GROUND WATER RECHARGE

PHOENIX URBAN STUDY

FEBRUARY 1977

COMMENTS ON "GROUND WATER RECHARGE PHOENIX URBAN STUDY February 1977"

GROUND WATER RECHARGE
PHOENIX URBAN STUDY
SALT RIVER INFILTRATION BASIN-PLAN I
U S ARMY ENGINEER DISTRICT
LOS ANGELES, CORPS OF ENGINEERS
TO ACCOMPANY REPORT DATED:

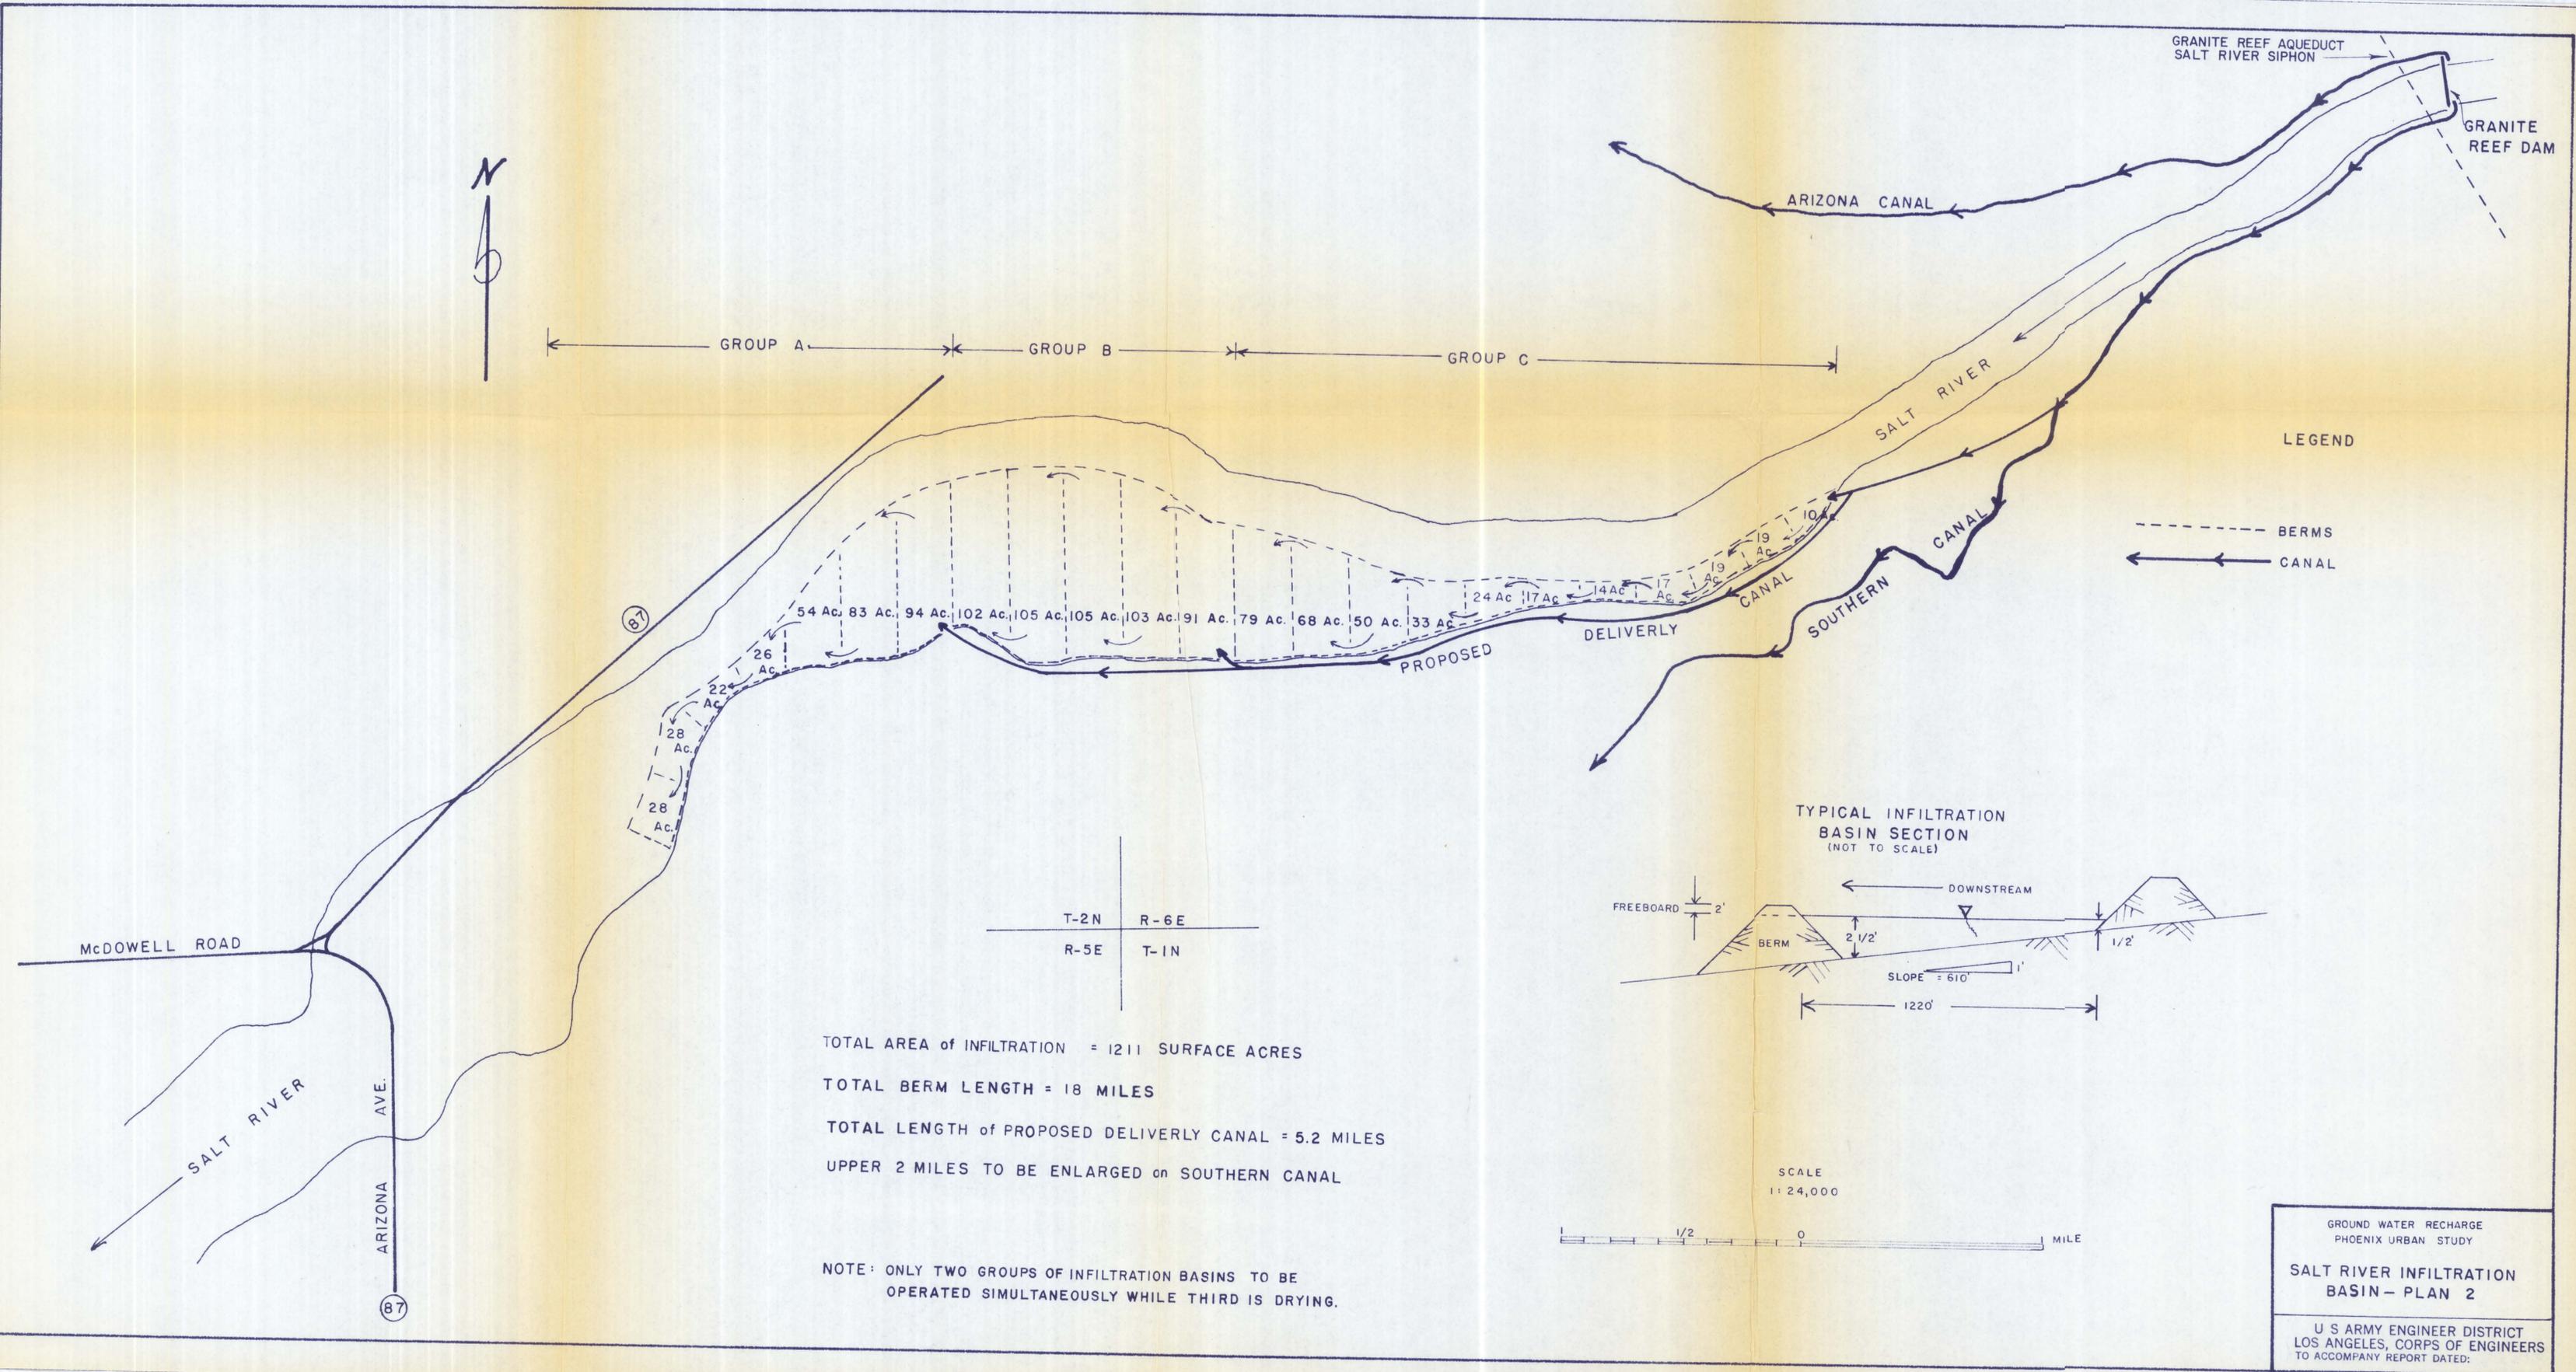
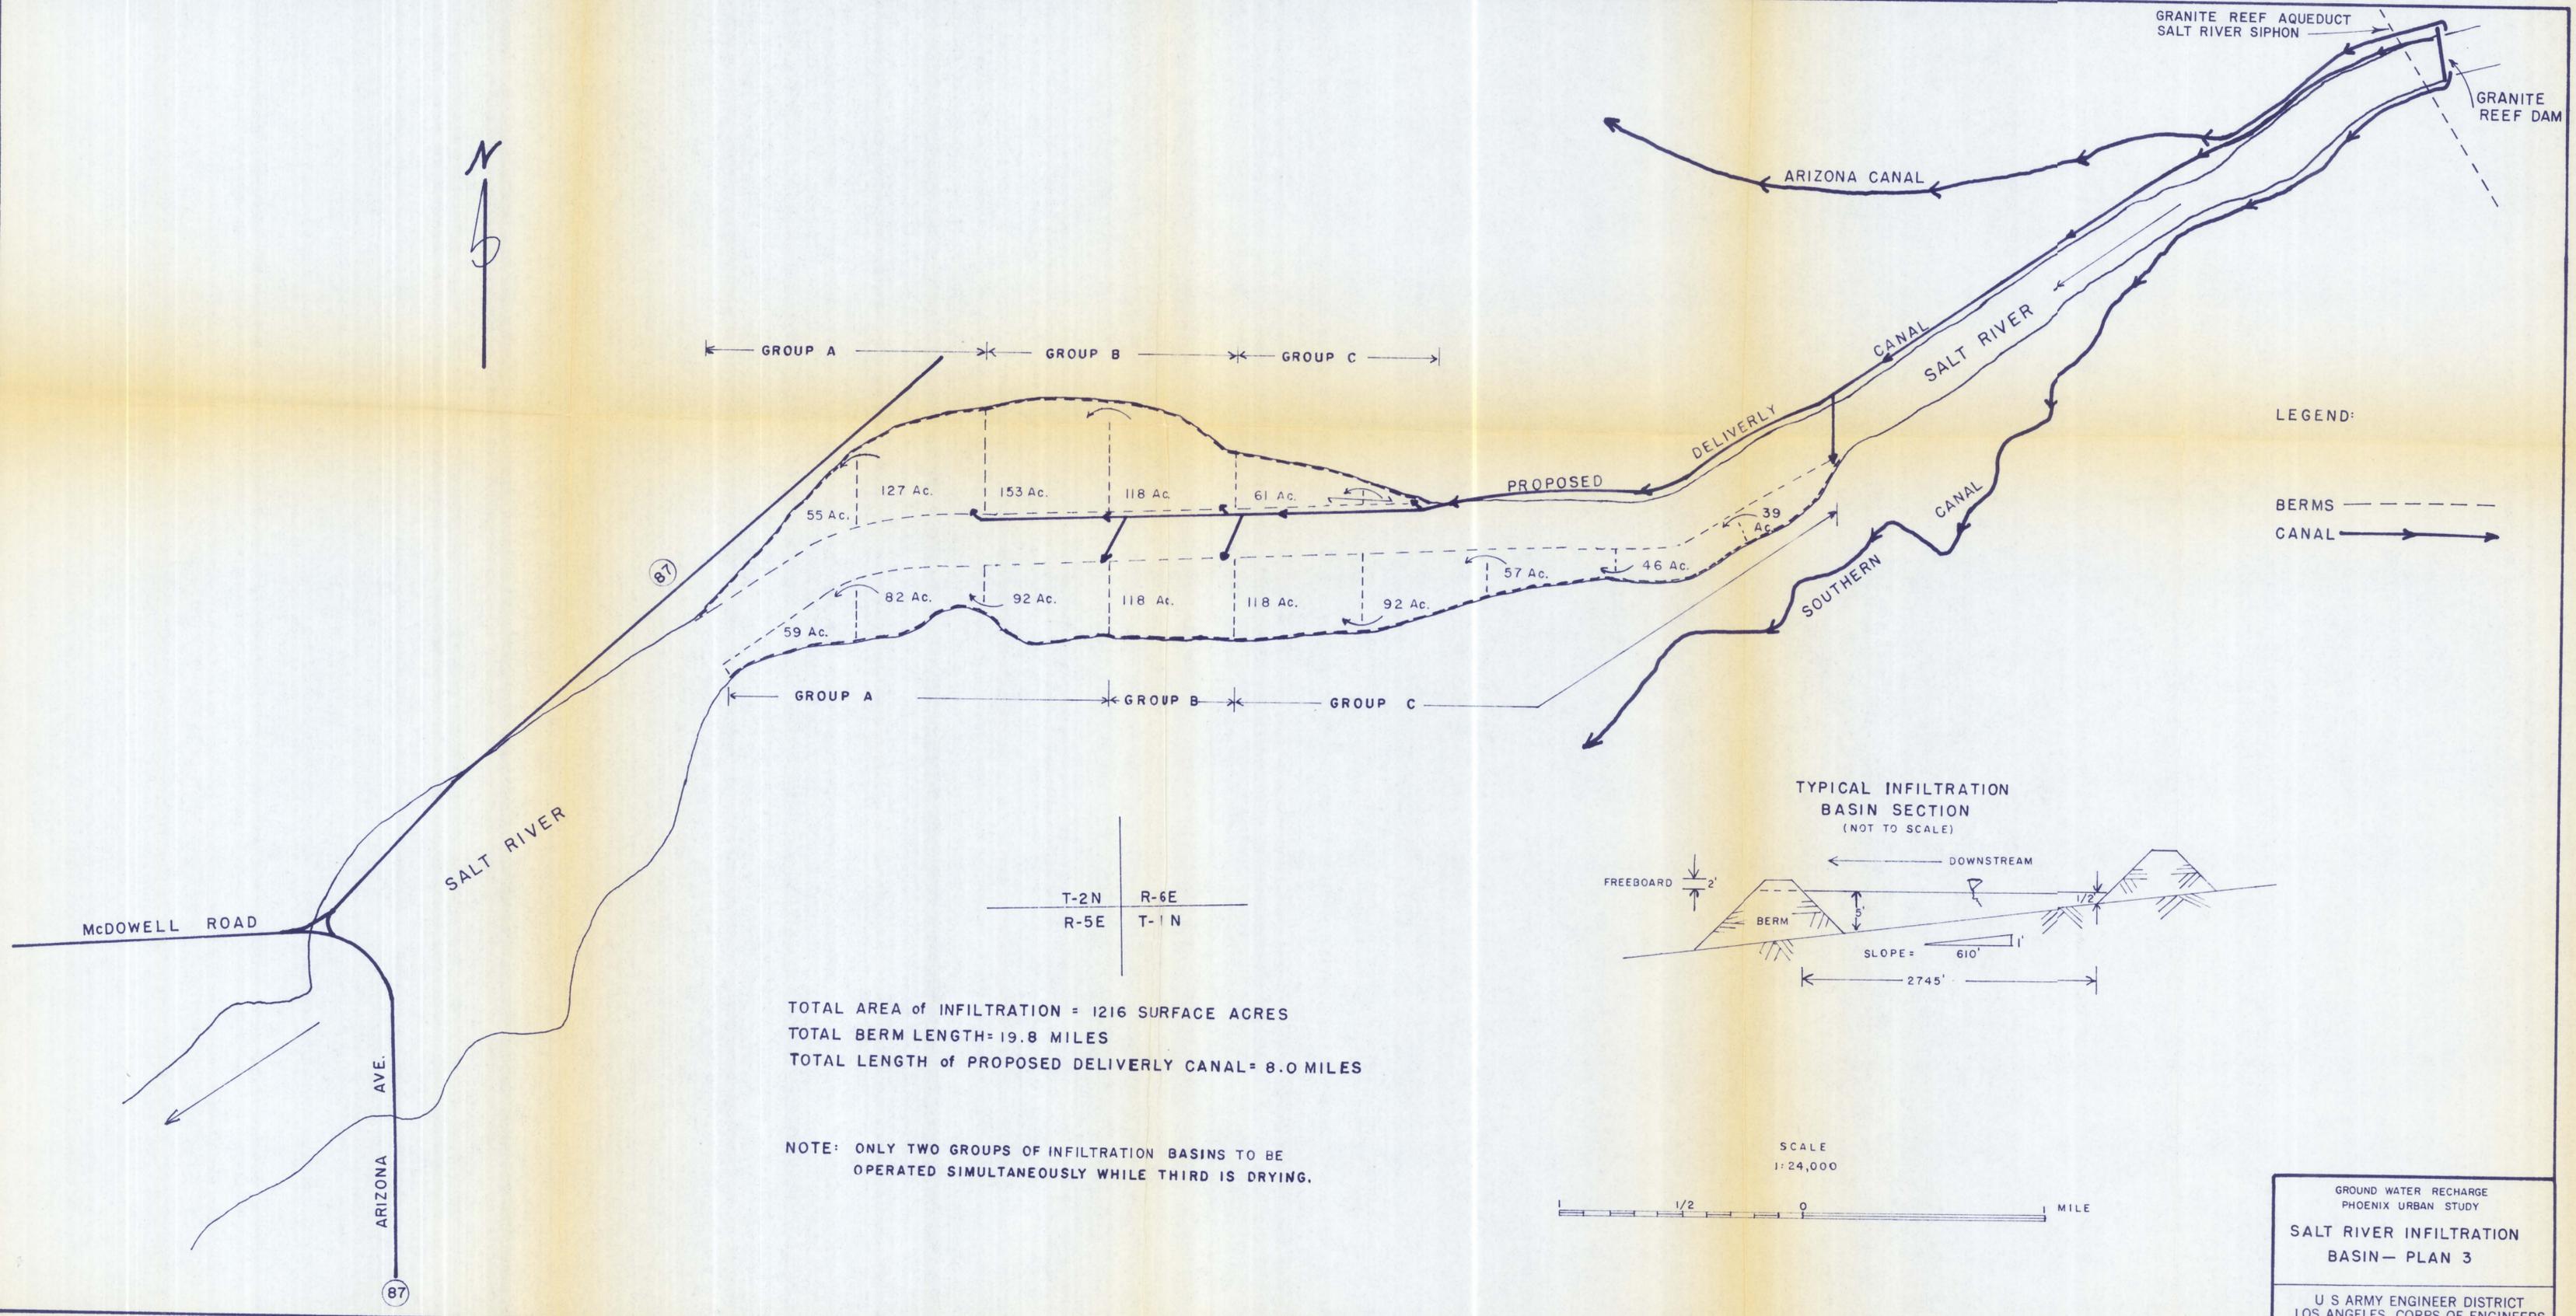
A cursory examination of aerial photographs taken in 1976 and 1977 indicates that there are about 1,000 acres of excavated areas in the Salt River between the Baseline Highway and 35th Avenue. This compares favorably with the Corps estimated area requirement for recharge of 2,000 cfs or 850,000 acre feet/year to allow joint use storage in the Orme Dam flood control pool (paragraph 3.04). That is, it compares with the abilities of the systems shown in Plates 3, 4 and 5.

It should be noted that part of the recharge areas shown on Plates 3, 4 and 5 are located on the Salt River Indian Reservation. While realizing that this is a technical report, I think that consideration should be given to consultation with the Tribal Council, along with other legal considerations discussed in Paragraph 1.04c.
